**Technical Service
BULLETIN**

Title: **WOOD APPLIQUE KIT CHANGE**

Models:
'98 Land Cruiser

**ACCESSORY
AX004-98**

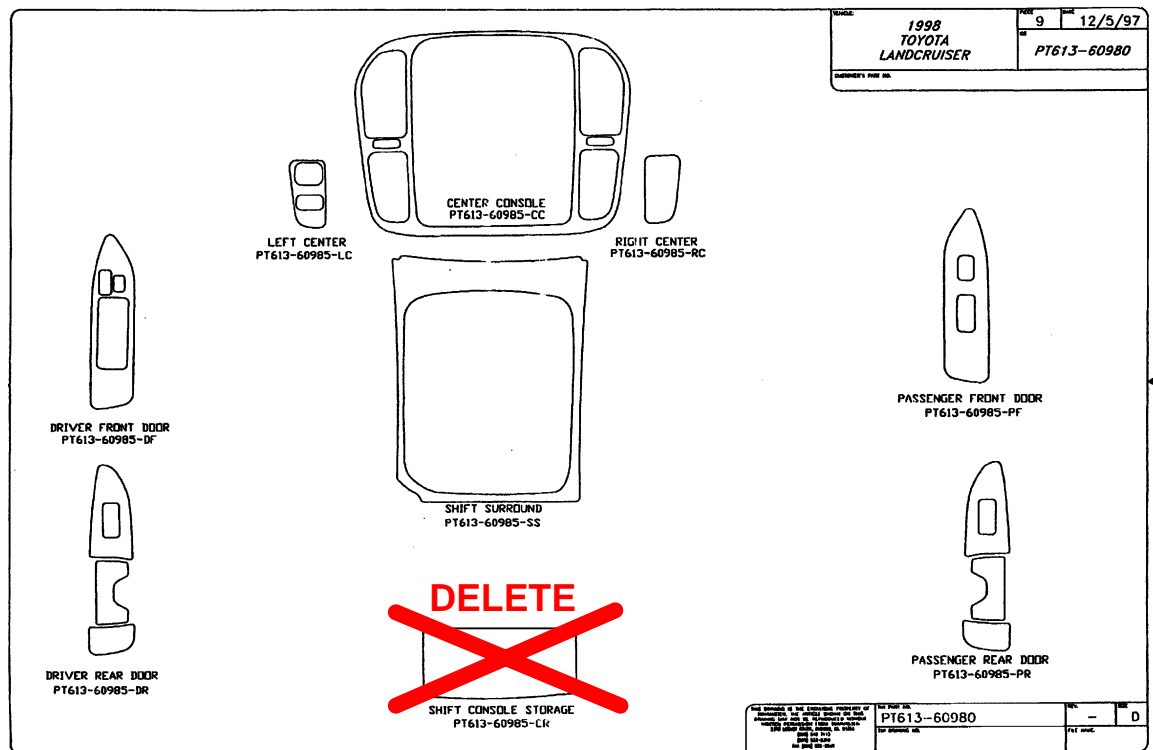
Introduction Due to variation in vehicle build tolerance the Shift Console Storage Door Fascia piece (Service P/N PT613-60985-CR) sometimes contacts the console when open. This causes a mark on the Shift Console Storage Door Fascia piece.

Repair Procedure Do not install the Shift Console Storage Door Fascia piece. This part will not be warrantable. Install Wood Kit as instructed with exception of this part.
